**ADDENDUM NUMBER ONE**  
**to the**  
**PROJECT SPECIFICATIONS and CONTRACT DOCUMENTS**  
**for the**  
**Darby Creek Way Reconstruction Project**

**DATE OF ADDENDUM:** March 28, 2016

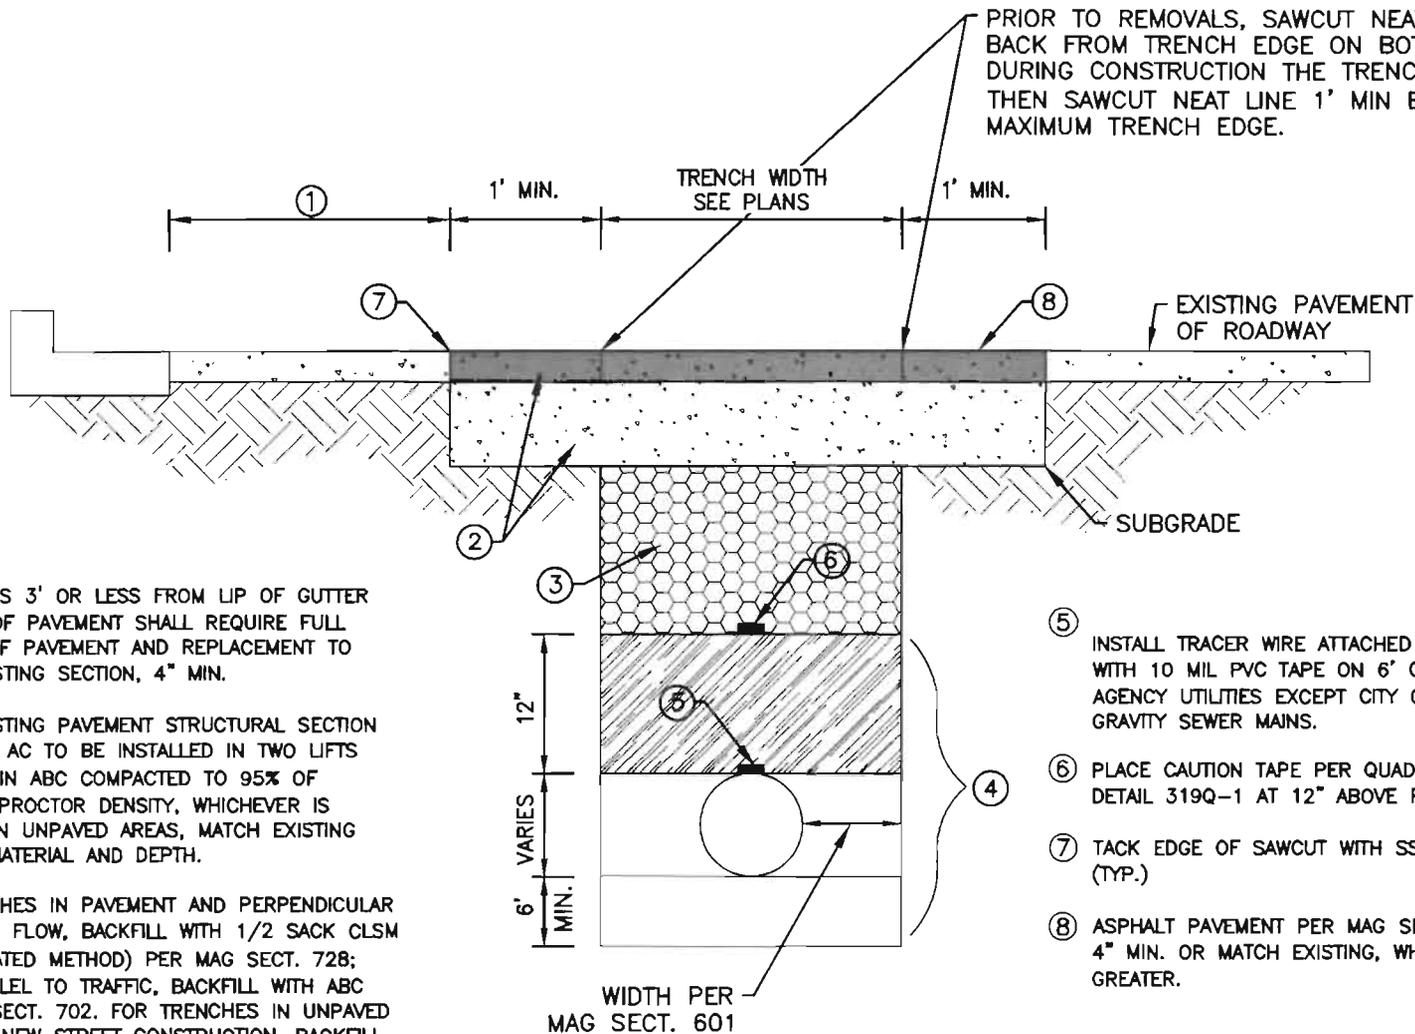
**Clarification** - The COP standard detail called for on the plans for Trench Backfill and Surface Replacement is outdated. Trench Backfill and Surface Replacement shall be per Quad City Standard Detail 200Q, attached hereto.

- ① EXCAVATIONS 3' OR LESS FROM LIP OF GUTTER OR EDGE OF PAVEMENT SHALL REQUIRE FULL REMOVAL OF PAVEMENT AND REPLACEMENT TO MATCH EXISTING SECTION, 4" MIN.

- ② MATCH EXISTING PAVEMENT STRUCTURAL SECTION OR 4" MIN AC TO BE INSTALLED IN TWO LIFTS OVER 8" MIN ABC COMPACTED TO 95% OF STANDARD PROCTOR DENSITY, WHICHEVER IS GREATER. IN UNPAVED AREAS, MATCH EXISTING SURFACE MATERIAL AND DEPTH.

- ③ FOR TRENCHES IN PAVEMENT AND PERPENDICULAR TO TRAFFIC FLOW, BACKFILL WITH 1/2 SACK CLSM (CONSOLIDATED METHOD) PER MAG SECT. 728; AND PARALLEL TO TRAFFIC, BACKFILL WITH ABC PER MAG SECT. 702. FOR TRENCHES IN UNPAVED AREAS OR NEW STREET CONSTRUCTION, BACKFILL TRENCH TO SURFACE WITH 3" MINUS SCREENED NATIVE MATERIAL.

- ④ GRANULAR BEDDING/SHADING MATERIAL SHALL BE PER MAG SECT. 601 WITH 100% PASSING 1" SIEVE, MAXIMUM 10 P.I.. THE COMBINATION OF PERCENT MATERIAL PASSING THROUGH #200 PLUS P.I. SHALL NOT EXCEED 22.

- ⑤ INSTALL TRACER WIRE ATTACHED TO TOP OF PIPE WITH 10 MIL PVC TAPE ON 6' CENTERS ON ALL AGENCY UTILITIES EXCEPT CITY OF PRESCOTT GRAVITY SEWER MAINS.
- ⑥ PLACE CAUTION TAPE PER QUAD CITY STANDARD DETAIL 319Q-1 AT 12" ABOVE PIPE.
- ⑦ TACK EDGE OF SAWCUT WITH SS1H WHEN PAVING. (TYP.)
- ⑧ ASPHALT PAVEMENT PER MAG SPECIFICATION 710. 4" MIN. OR MATCH EXISTING, WHICHEVER IS GREATER.

NOTE: BEDDING, SHADING, AND BACKFILL SHALL BE COMPACTED TO 95% PROCTOR DENSITY PER ASTM D-698. MIN. 1 TEST PER LIFT PER 200'. EXPOSED SUBGRADE TO BE COMPACTED TO 95% PROCTOR DENSITY PER ASTM D-698. PAVED SURFACE TO BE COMPACTED TO 95% MARSHALL DENSITY PER ASTM D-6927-15.
